Project:	Project Name						Scale	Tot Pages				
Sub-Proj.:	Sub-Project Name						1:1	1				
Assembly:	Assembly Group Name							Page N°				
Created:	DD.MM.YYYY	Name	Dimensions	From	1	6		30	100	300	1000	1
Last Mod.:	DD.MM.YYYY	Name		To	6	30		100	300	1000	2000	
Constructed:	DD.MM.YYYY	Name	Tolerance	±0.1 0.2 0.3 0.5 0.8 1.2								
				PCB Board fixing slot				XX-XXXX

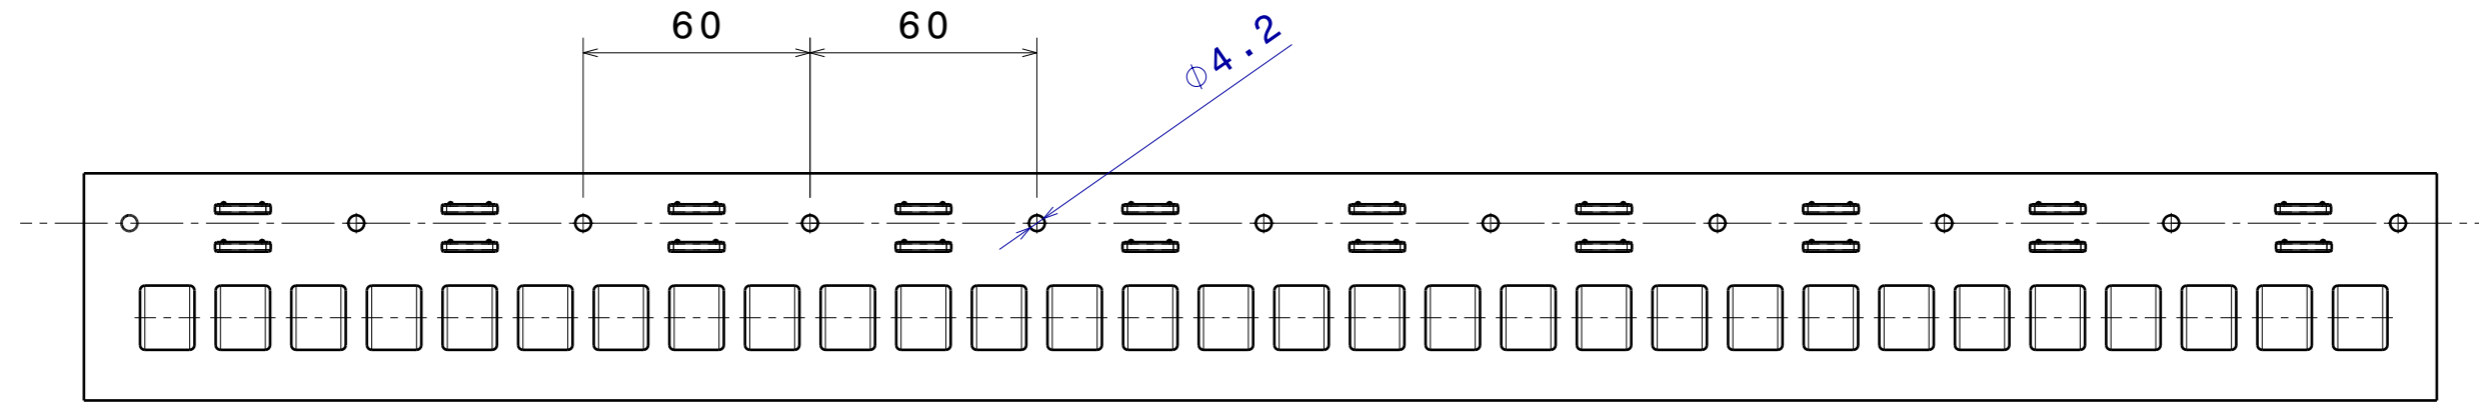
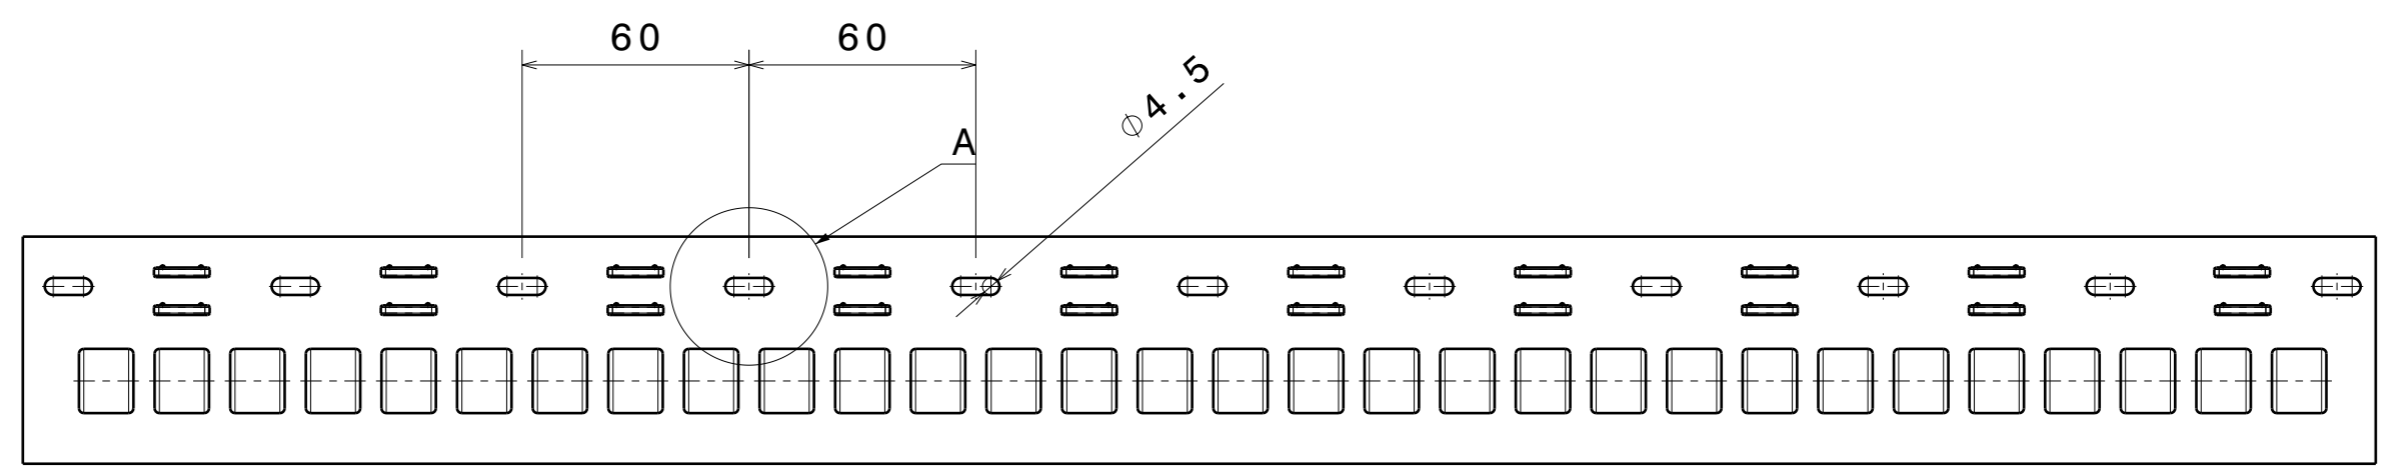
# PROPOSAL WITH SLOTS
